ITEM 10. SECTION 96(2) APPLICATIONS: 48-50 MARTIN PLACE SYDNEY - COMMONWEALTH BANK BUILDING**FILE NO:** D/2011/733/A AND D/2011/733/B**DEVELOPMENT APPLICATION NO:** D/2011/733/A AND D/2011/733/B**SUMMARY****Date of Submission:** 1 August 2012 (Amendment A) and 10 September (Amendment B)**Applicant:** Macquarie Bank Limited**Owner:** Macquarie Bank Limited**Architect:** Johnson Pilton Walker**Developer:** Macquarie Bank Limited**Proposal Summary:** Two separate, but nevertheless inter-related Section 96(2) applications to modify the original development consent have been submitted. This report provides a joint assessment for ease of understanding the totality of the modifications proposed in both applications.

12. Two separate, but nevertheless inter-related Section 96(2) modification applications have been submitted. This report provides a joint assessment for ease of understanding the totality of the modifications proposed in both applications

Figure 13 - Photomontage of proposed rooftop amendment from Elizabeth Street

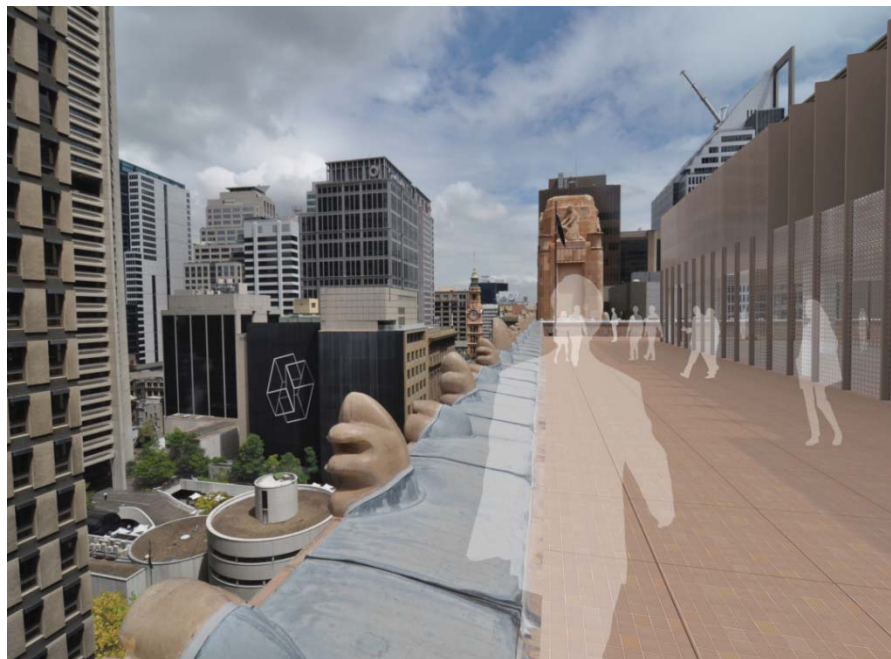
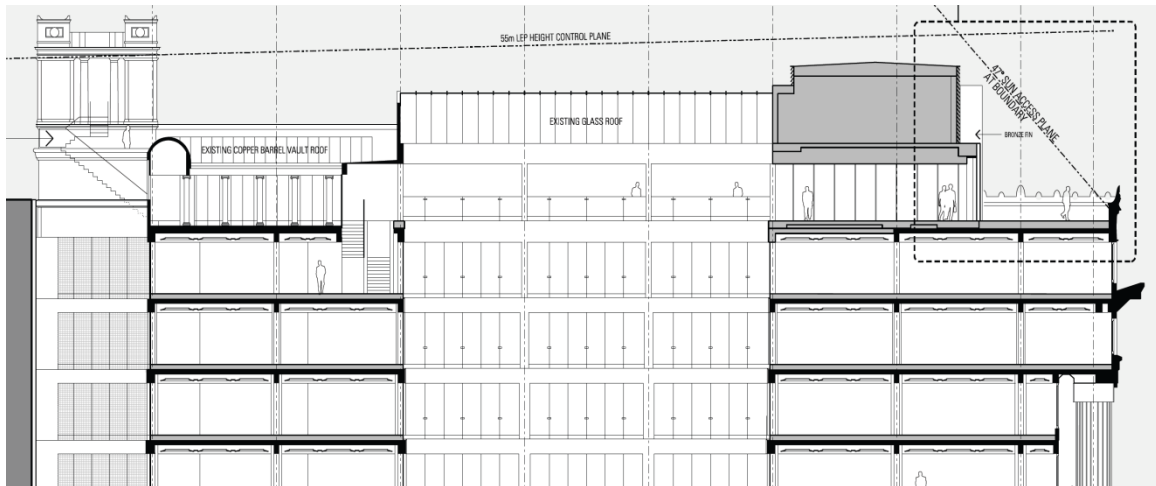
23. The proposed modification to the approved rooftop addition has merit and is supported. In particular, the following matters are noted:
- the building has had various rooftop configurations over time with the proposal having a positive impact when viewed from higher buildings surrounding the site and will read as a complete form which is formal, symmetrical and reflects that of the existing building;
 - the glazed dome form makes reference to the historic curved mansard roof and dome forms associated with Beaux Arts style architecture;

- (f) while the central part of the proposed roof is 1.95m higher than the approved roof, the amendment complies with the Local Environmental Plan (LEP) height control (ie. 55m height under the Martin Place Sun Access Plane);
- (g) while the proposed setbacks (ranging between 4.3m to 18m) do not comply with the Development Control Plan (DCP) required 'full' setback above a height of 45m (within the Martin Place Special Area), the proposal is considered acceptable having regard to the earlier comments and the following:
 - (i) the approved addition also had non-compliant setbacks;

- (a) existing Condition 6 (Design Quality Excellence) be modified to require details of the roof structure and glazing system to be approved by Council prior to the issue of a Construction Certificate;
 - (b) Council's standard condition on 'reflectivity' be imposed to minimise glare nuisance to surrounding buildings; and
 - (c) a condition be added requiring detail to be provided as to how the new raised floor and roof deck will be resolved where it meets the existing building parapet.
25. It is also recommended that existing Condition 3 (Building Height) be modified to ensure that the revised addition complies with the LEP height control (being 55m under the Martin Place Sun Access Plane).

Figure 27 - East-west section (existing 6m wide atrium shown in blue; proposed 10.5m wide atrium shown in green)

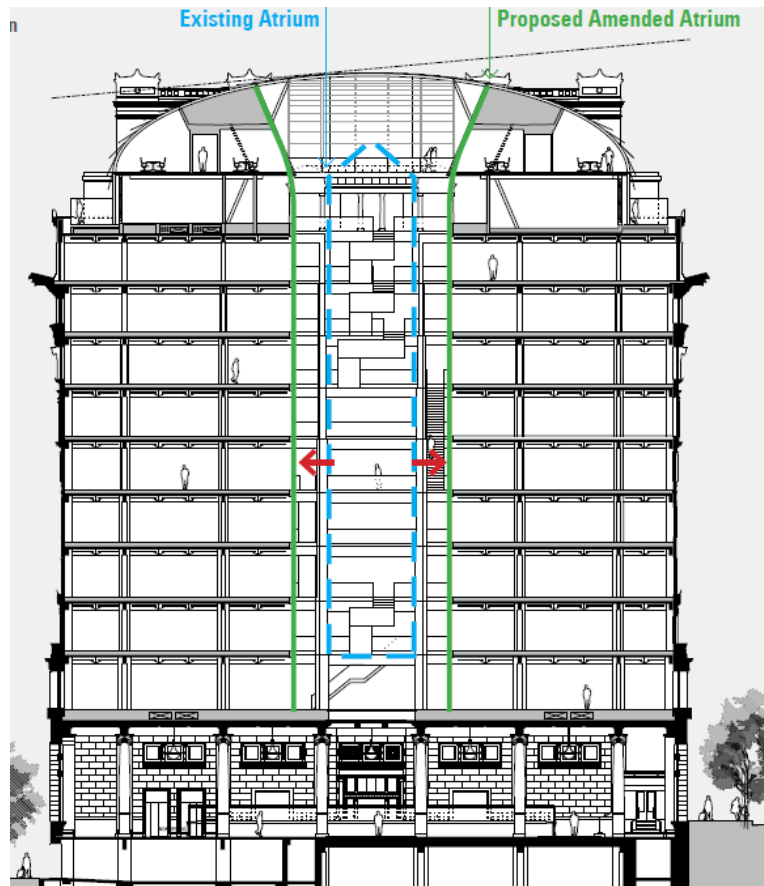
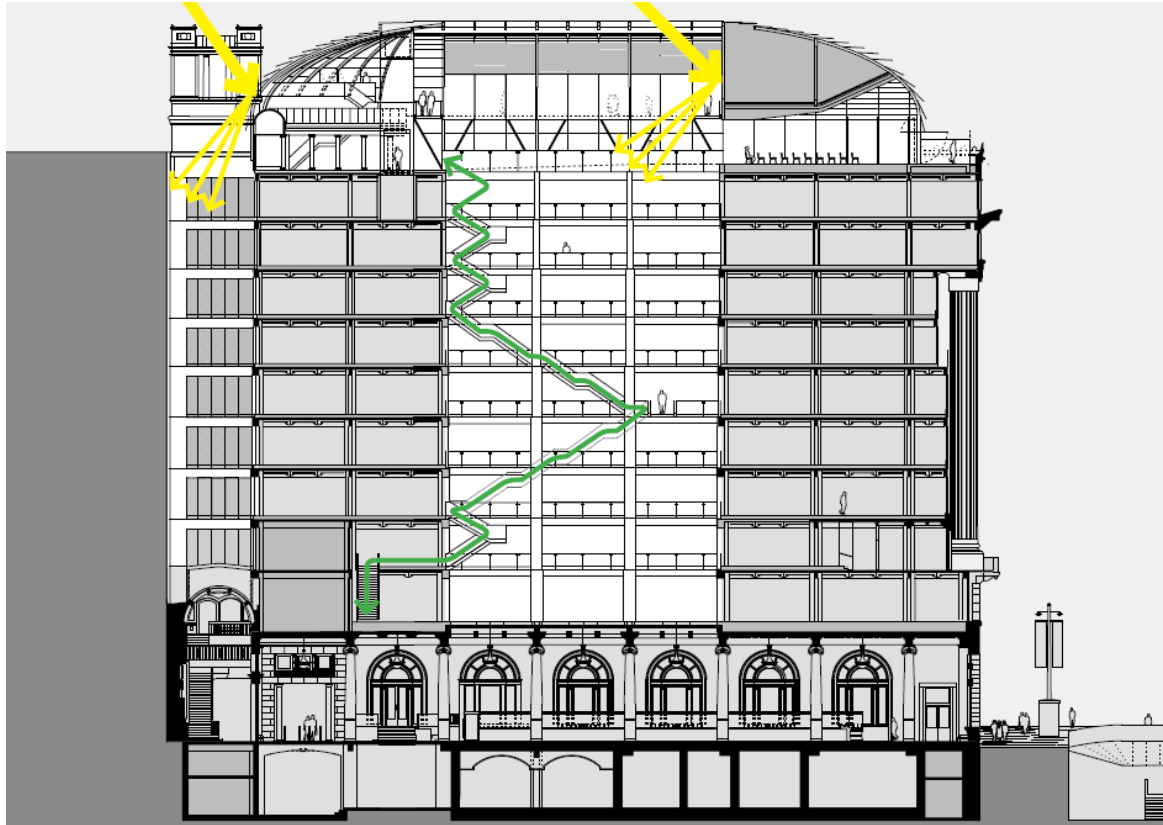
27. The proposed atrium enlargement and provision of interconnecting stairs have merit and are supported. In particular, the following matters are noted:

- (a) the original function of the atrium was utilitarian in nature (for services, light and ventilation) and not designed as a space to be looked into and appreciated – the changes are not therefore being made to an ‘architectural’ space;

- (b) the enlarged atrium will enhance the atrium proportions and allow daylight to penetrate deeper into the interior spaces, with the associated environmental benefits;

- (f) the interconnecting stairs will improve internal connectivity, though will need further refinement – a condition to this effect is recommended.

- (a) The design resolution of the interconnecting stairs at the northern edge of the atrium should endeavour to minimise the extent of cantilever into the original portion of the atrium.

- (b) The design of the interconnecting stairs at the northern edge of the atrium should avoid demolition of the northern perimeter beam exploring alternate structural systems, such as suspended, or revised landing locations on the eastern and western edges of the atrium.

Figure 32 - Proposed glass shuttle lifts

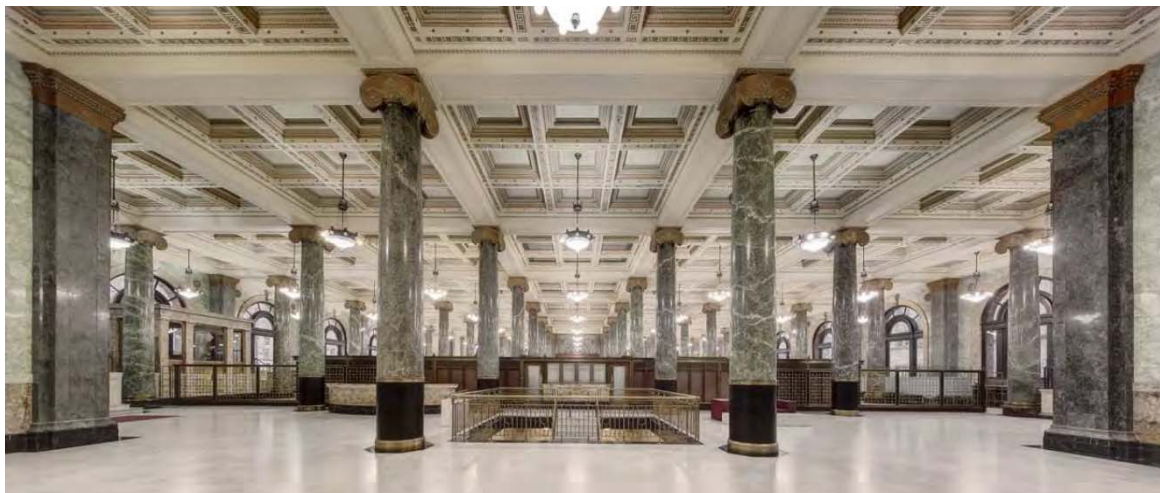
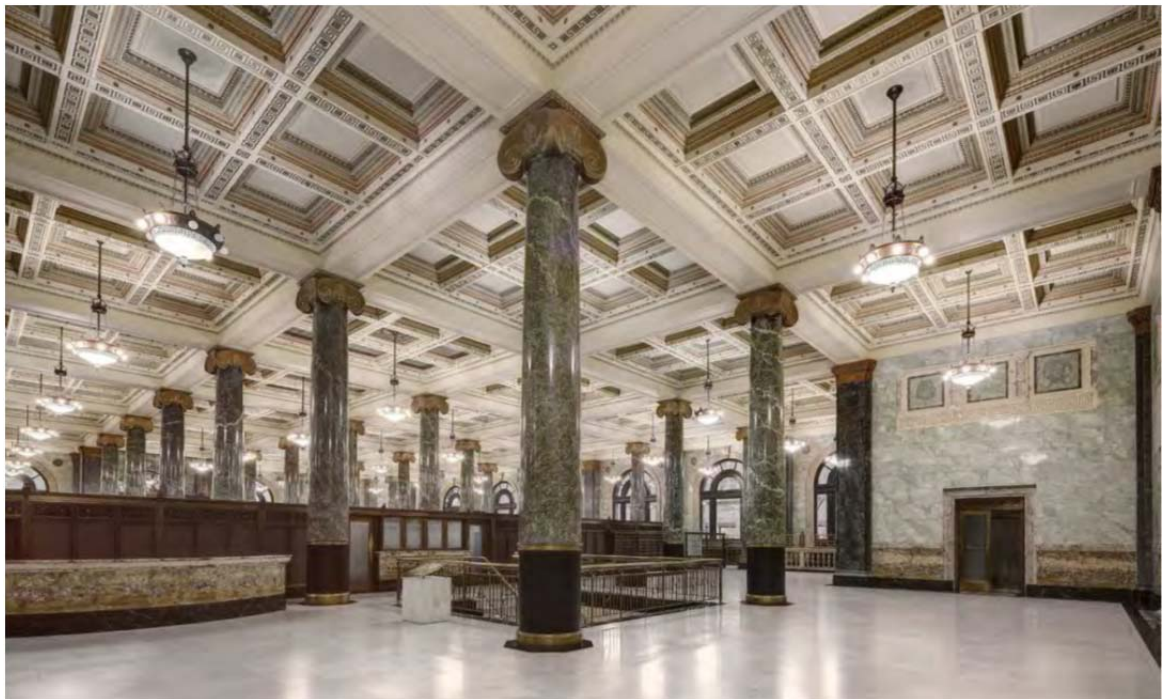
33. The proposed new lifts are supported. In particular, the following matters are noted:
- (a) the visual impact of the new lifts have been minimised;
 - (b) the location of the new lifts is such that the lift pits will replace the 1980s access stair, will not obscure the heritage significant roof elements, and will be encapsulated within the new roof structure;
 - (c) the axial location reinforces the symmetrical layout of the original floor plates and does not restrict or impact on the original floor circulation pattern;
 - (d) the use and logic of the original office lift lobbies are retained; and
 - (e) both the City's heritage staff and the NSW Heritage Council support the proposal subject to conditions - these conditions have been included in the Recommendation.

6. Construction detail drawings and finishes of the proposed glass shuttle lifts that demonstrate the architectural Design Statement claims are to be submitted with the section 60 application for assessment and approval.

7. Construction detail drawings and finishes of the reproduction ceiling panels flanking the glass shuttle lifts' void in the Banking Chamber are to be submitted with the section 60 application for assessment and approval.
